CITY OF PUYALLUP ENGINEERING SERVICES

Project Title: LARSON **RIVER ROAD STORAGE**

PERMIT SET

GRADING SECTIONS

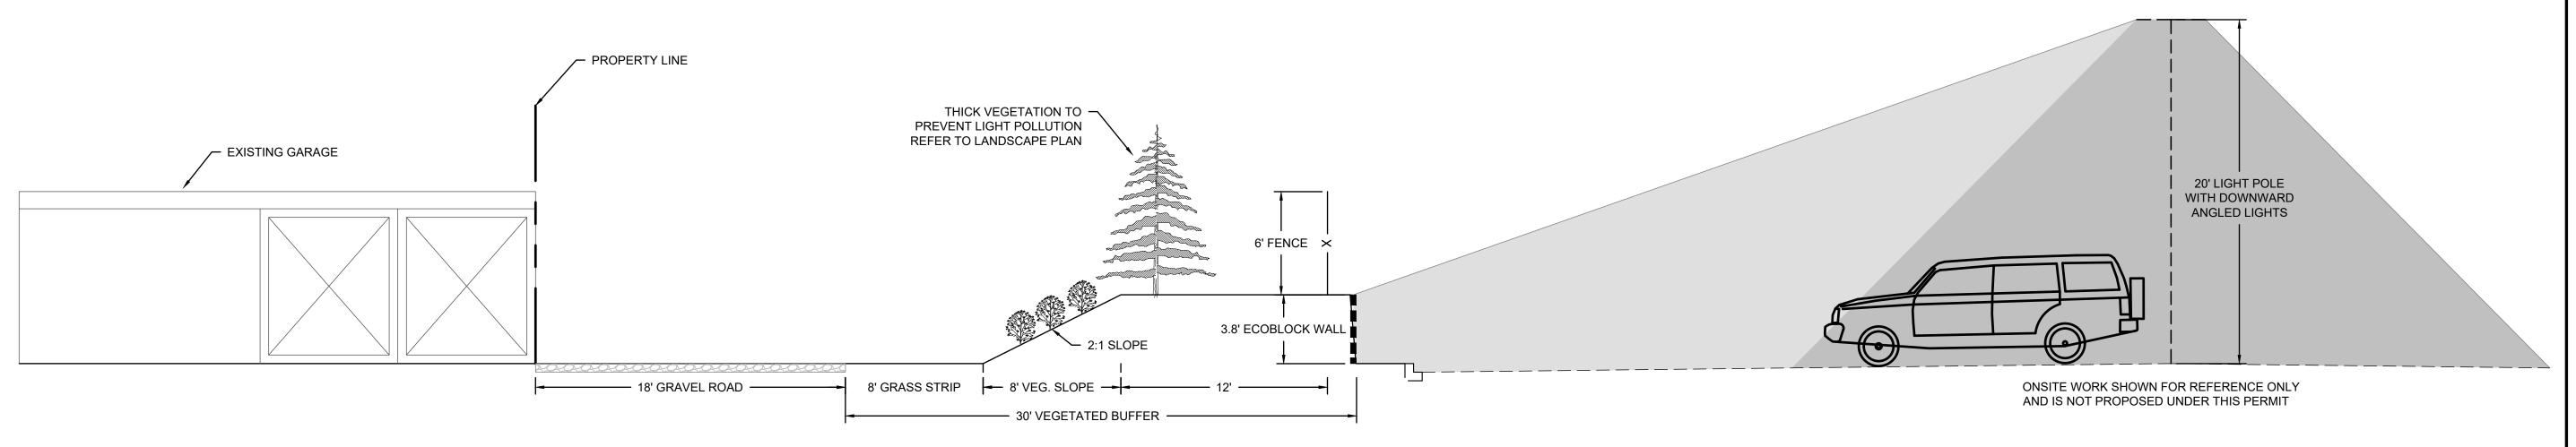
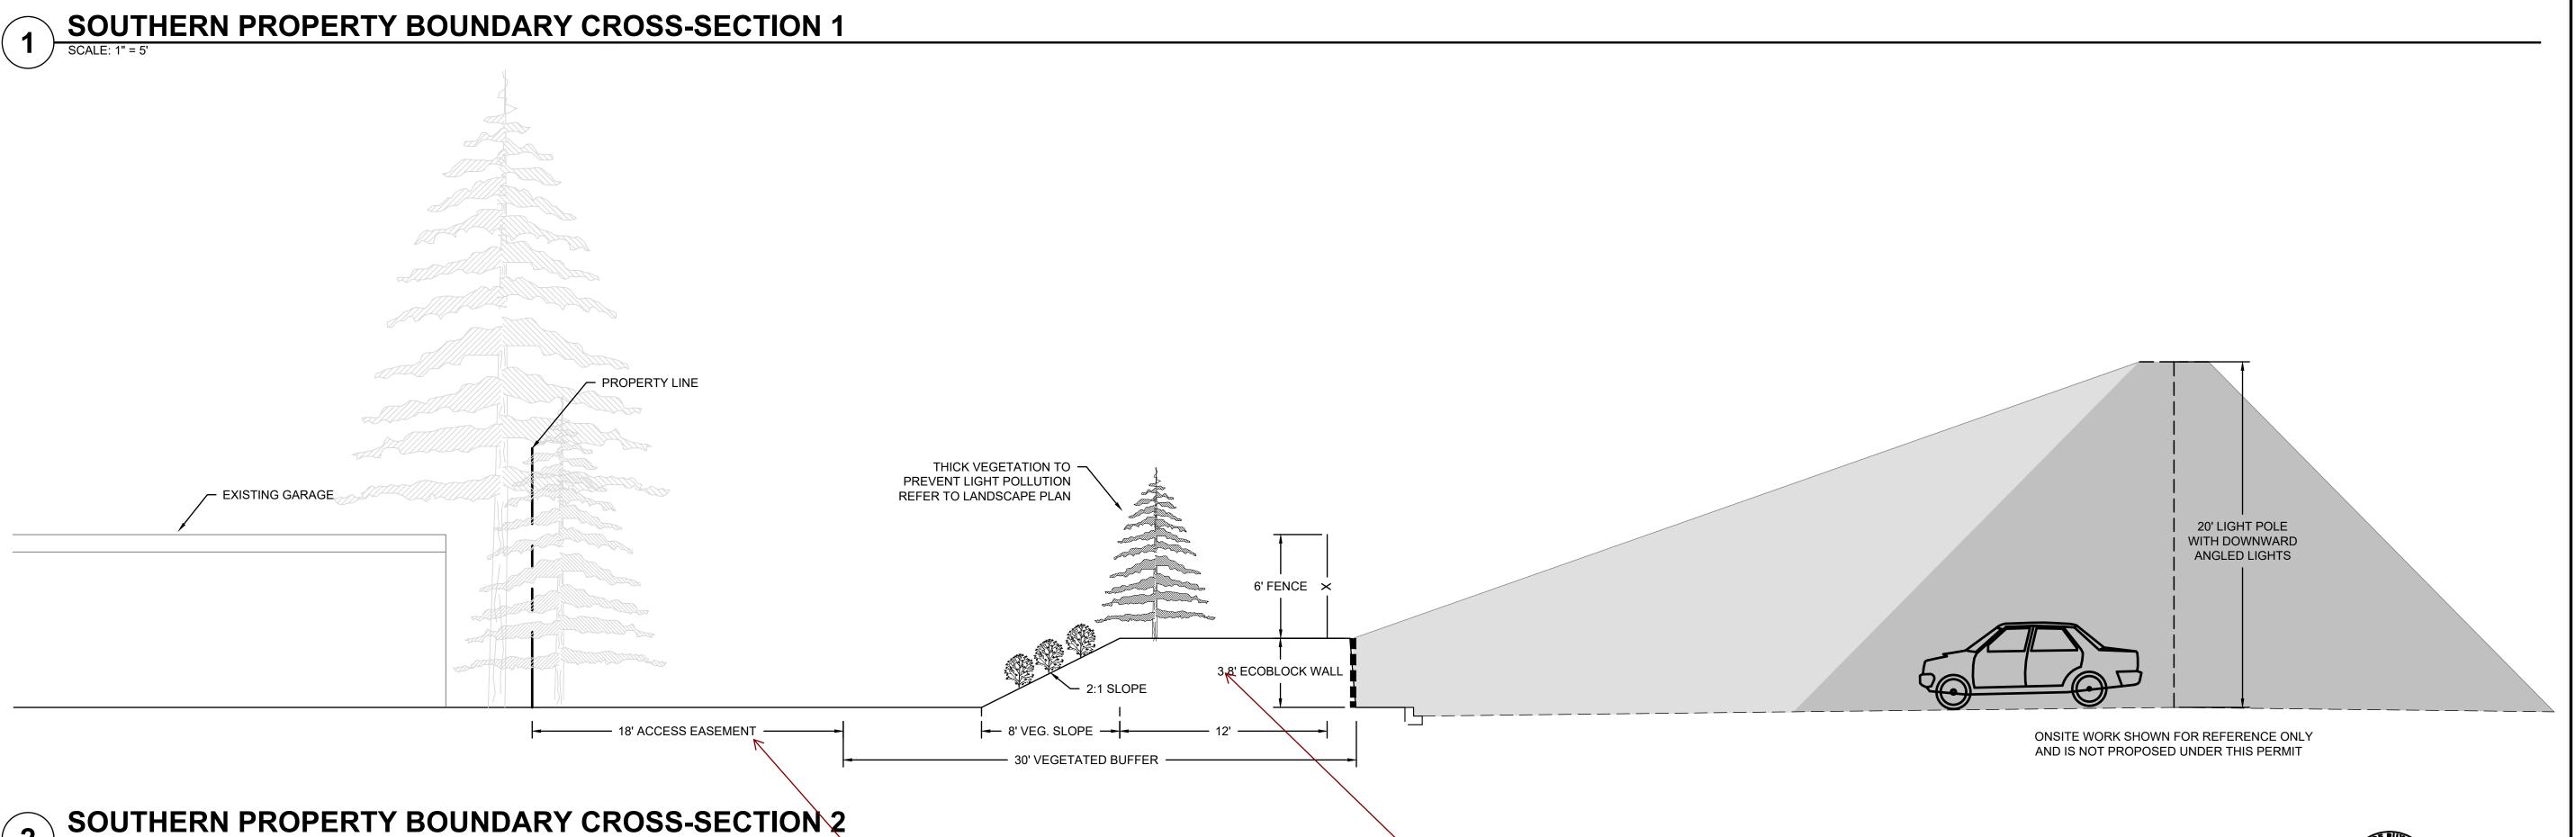
Double check all recorded documents associated with the affected parcels. In some areas the easement along the

> southern property line is suspected to be 24 feet

wide. Provide private

easement documentation

to verify dimensions of burdened areas.

height of this wall or provide specs from manufacturer of custom eco blocks.

Standard eco blocks are

two feet tall. Clarify the
